HISTORIC AND DESIGN REVIEW COMMISSION

HDRC CASE NO: 2016-238
ADDRESS: 315 W LYNWOOD
LEGAL DESCRIPTION: NCB 6386 BLK 6 LOT 13 THRU 22
ZONING: R5 H
CITY COUNCIL DIST.: 1
DISTRICT: Monte Vista Historic District
APPLICANT: Lauren Dillberto
OWNER: Dennis Karbach, Robert Brown
TYPE OF WORK: Conceptual approval for installing windows, new construction of a garage, driveway modifications, landscaping

315 W. Lynwood Ave. Restoration
San Antonio, TX 78212

1 SITE PLAN
 Scale: 1/16"=1'-0"

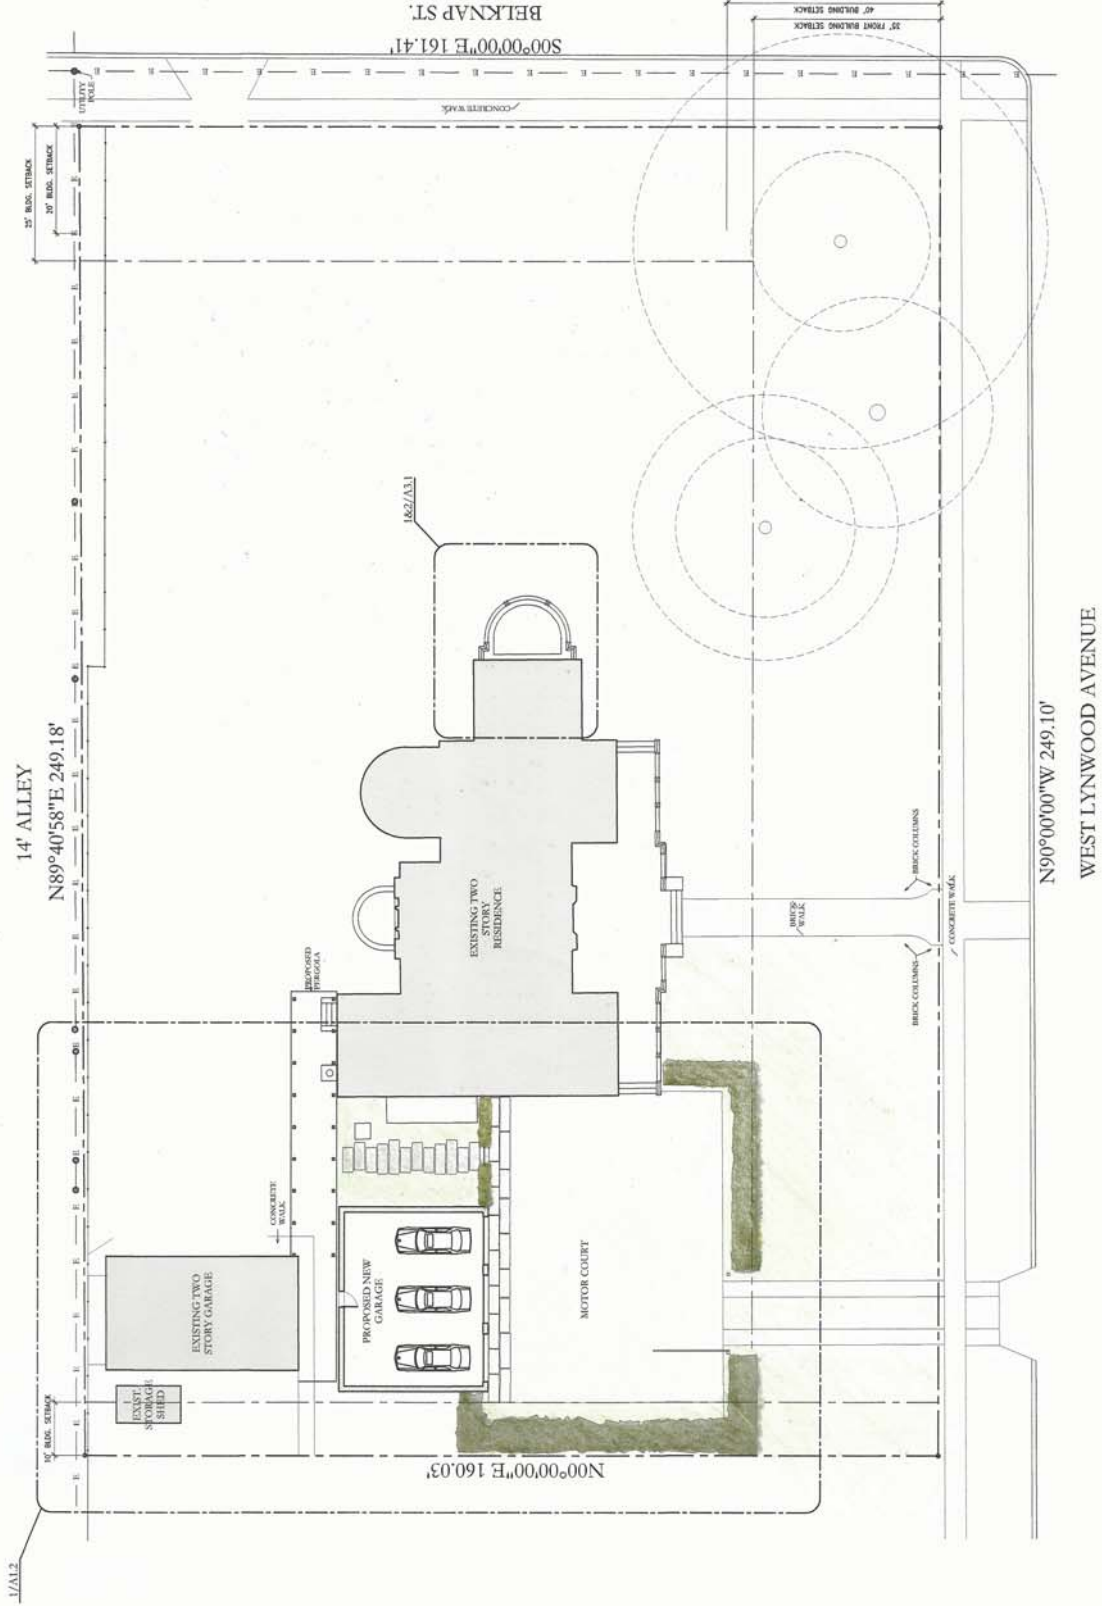
- b. REQUEST #2 - Currently, there is a concrete driveway entering from Belknap behind the main structure. The applicant is requesting to install a new driveway and approach entering from W Lynwood. As stated in finding d, staff found that most homes along W Lynwood have a front facing garages; staff also found that driveways are historically 10' wide and on the west of the main structure as the applicant has proposed. Staff finds the orientation and construction of the driveway appropriate and recommends that the driveway be up to 10' wide.

- d. REQUEST #4 - Remove existing driveway and install a great lawn, tree Bosque, a terrace between proposed garage and main structure, a swimming pool with deck area and install gravel terrace and seating area. According to the Guidelines for Site Elements 3, new plantings should be drought tolerant, no more than 50% of historic lawns should be removed, and pervious materials should be used with incorporated small plantings. Staff finds these proposed landscaping changes appropriate and consistent with the Guidelines, but that plant and material details should be provided with the final approval application.

- 1. That the driveway be no wider than 10' and be made of permeable materials.
- 2. That the applicant submit a photo or drawing of the proposed fence and paint color to staff to approve administratively.
- 3. That the applicant consult with the City Arborist in regards to the request to plant 19 Texas Sabal Palm trees.

Exterior Elevations & Door Details at Loggia

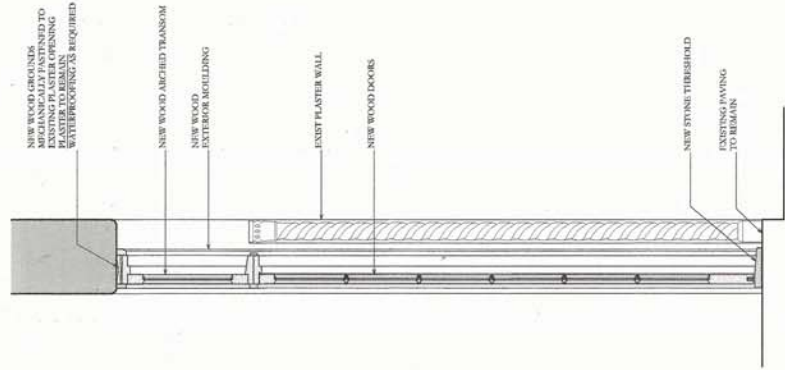
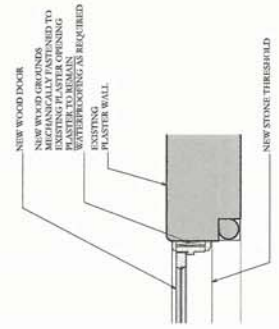
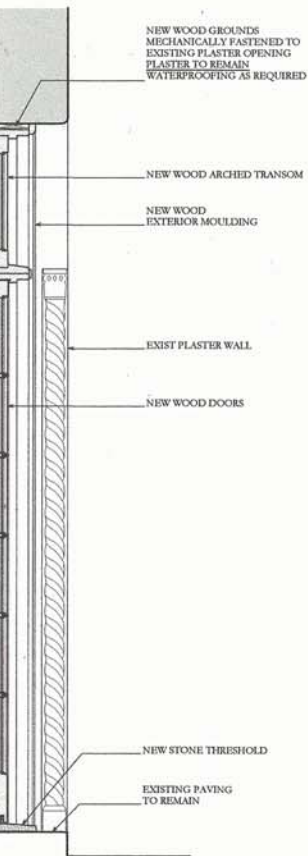
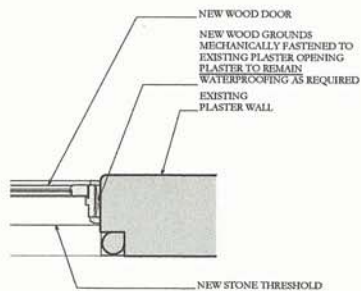
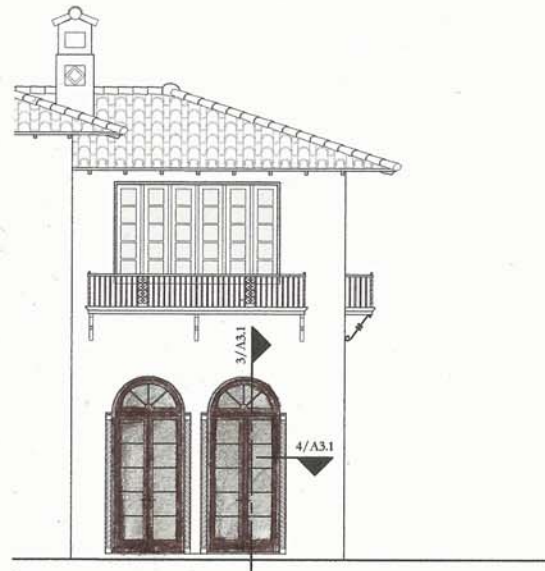
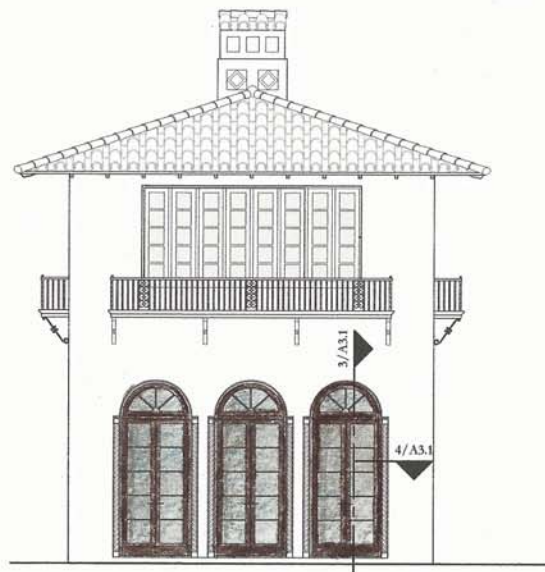
- c. REQUEST #3 - The applicant is proposing to enclose and install seven new narrow stile doors at East loggia. Currently, the loggia has seven arched openings facing a patio and the east lawn. The applicant provided current photographs of other homes in the district that have enclosed loggias. The doors to be installed will be narrow stile doors, each with 12 paneled lights and 4 fan lights, set back 10" beyond the exterior wall. According to the Guidelines for Exterior Maintenance and Alterations 6 states to avoid altering openings and use doors or windows that reflect the architectural style of the building. Staff finds the placement and style of the doors appropriate as they will not alter the window opening and the doors are appropriate for the Spanish Eclectic style.

Enlarged Plan - Garage Addition

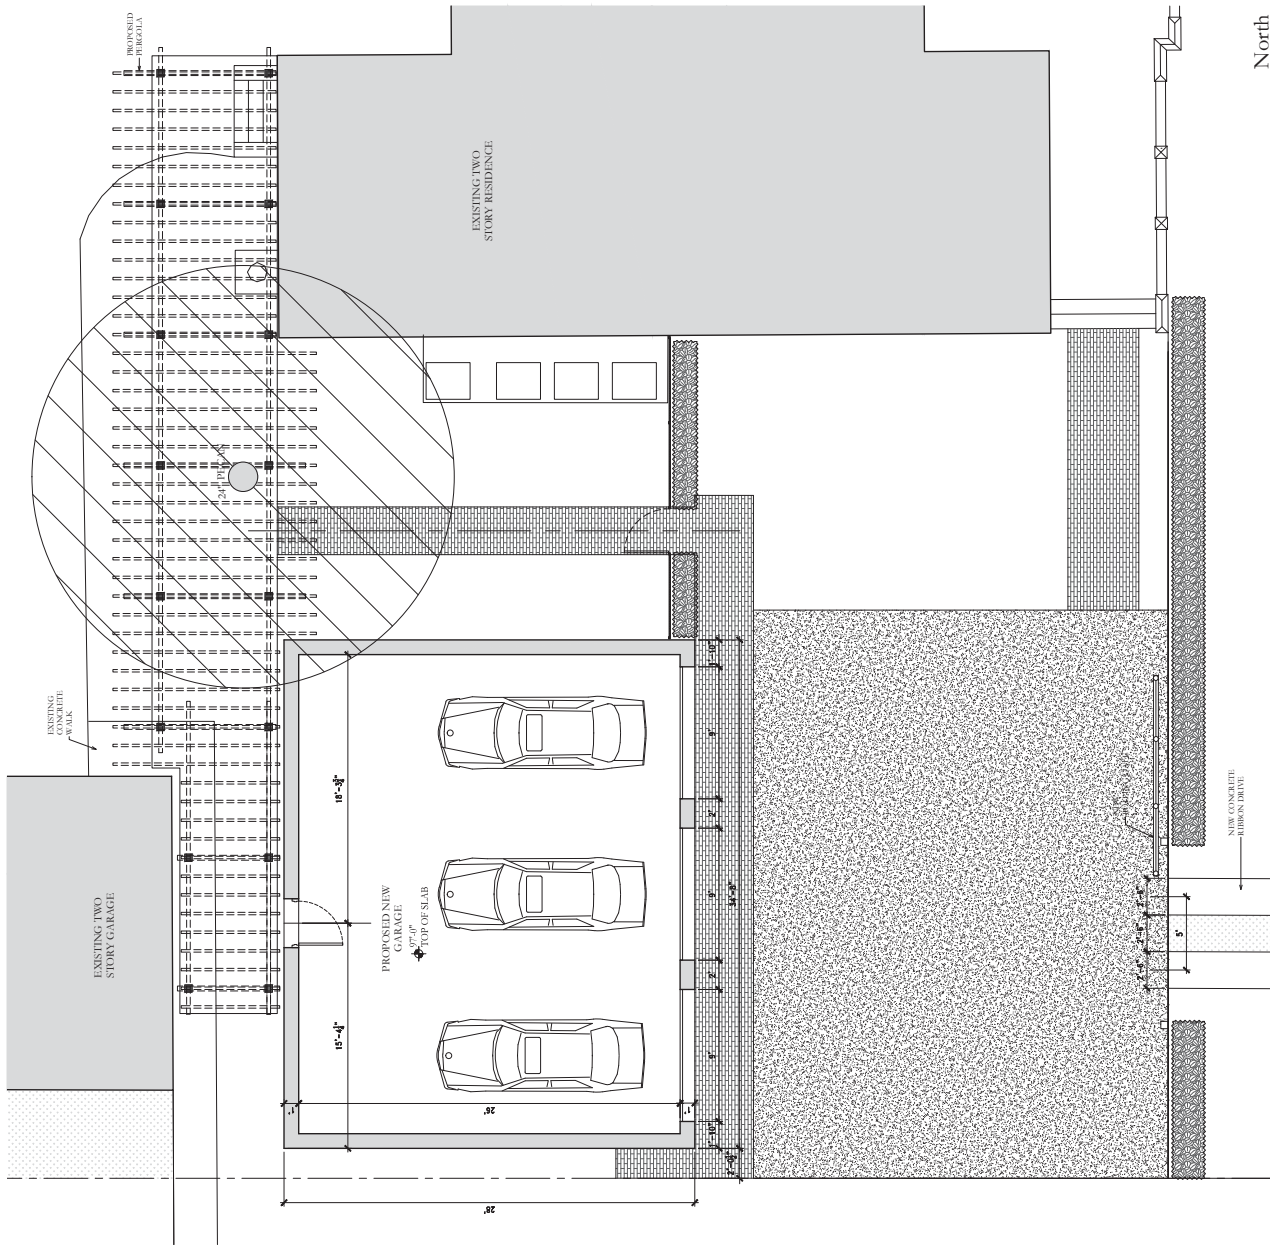
- a. REQUEST #1 PROPOSED - The applicant is proposing to construct a one-story garage facing W Lynwood set back behind the front façade; the new garage will have three bays, a flat roof, a clay tiled roof, stucco siding and be connected to the main structure with a pergola. According to the Guidelines for New Construction, new buildings should be sited to minimize visual impact from the public right of way, should be designed to be in keeping with the historic main structure, should utilize a similar roof form, and use complementary materials. Staff made a site visit on June 21, 2016, and found that most homes along W Lynwood have a front facing garages. Staff also finds that the proposed orientation, scale, massing, roof form, materials, and architectural details consistent with the Guidelines for New construction 2 as it relates well to the historic structure and is appropriately oriented.

to speak in favor at meeting. AMG: Show reduced elevation

CORNER HEDGE TREATMENT

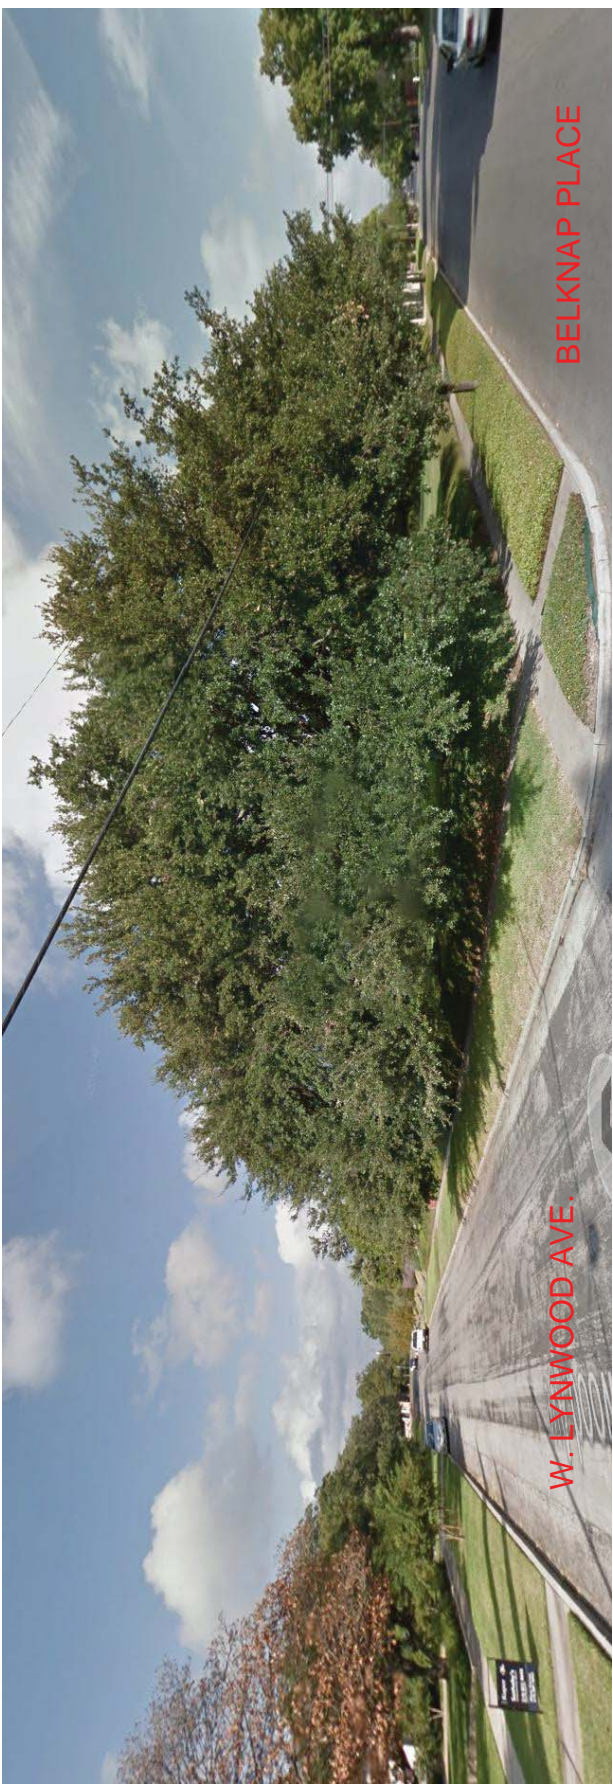
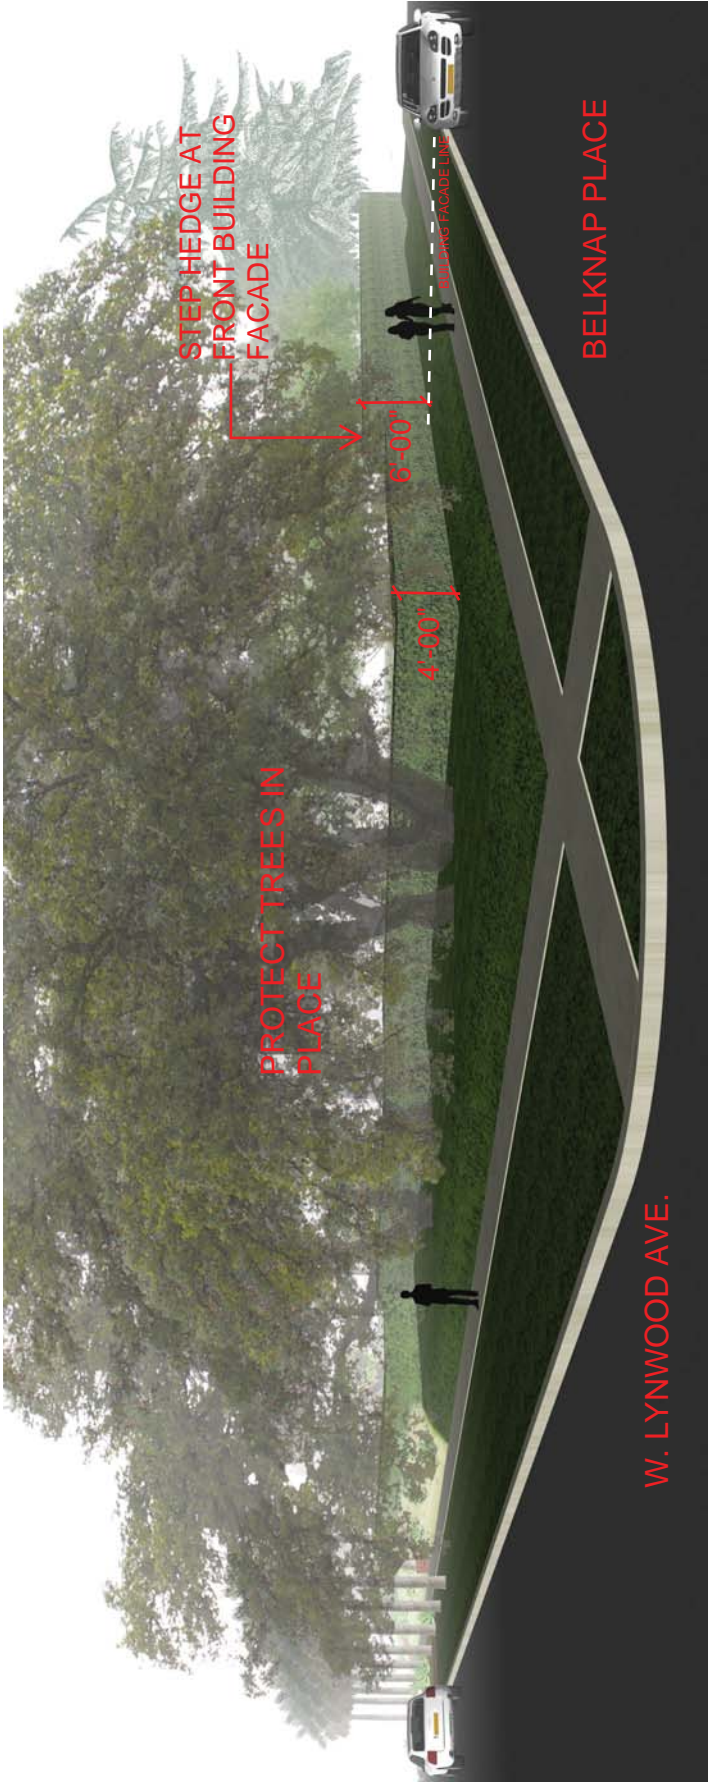
- g. REQUEST #7 – Currently, there is no fence or wall along the front property line, but railings that line the red brick stairs up to the front walkway. The front lawn also exhibits a steep berm along the front sidewalk. The applicant is proposing two options for their request to install a front yard hedge fence. Option 1 is preferred by the applicant. The applicant is proposing in option 1 to install a 4' hedge parallel to the front property line from the corner of the 6' hedge stair casing across the front lawn, parallel to the front sidewalk behind the stairs and at top of the existing berm, along the east of the proposed driveway, and terminating at the end of the proposed driveway gate. The two gates proposed are 4' iron gates across the existing walkway and proposed. According to

the Guidelines for Site Elements 2, front yard fences and walls should only be introduced in historic districts that historically have them. Staff made a site visit on June 21, 2016, and found that front yard hedges are historically found in Monte Vista. Staff finds the proposed option1 hedge fence and gates appropriate in location, material, and height according to the Guidelines for Site Elements 2 as the proposal is similar to other historic fences.

COMMENTS/CONCERNS: BF: concerns about elevation

of 4' hedge vs. front facade. Concerns w
